Access Compliance Report Public Rights-of-Way (Pedestrian Signals)

Main Street: ORANGEWOOD_AVE Cross Street: DALE_ST Location: NW

ADA ID: SGRK210928112557 Signal Type: One Push Button-Non APS Overall Compliance: No Severity Scores: BTN 1: 35 BTN 2: N/A No BTN: N/A

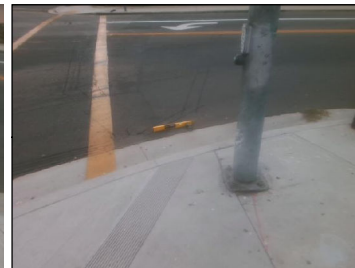
Surveyor Notes: N/A

Possible Solutions: Replace Signal Push Button With APS Button. Remove and Replace Clear Space.
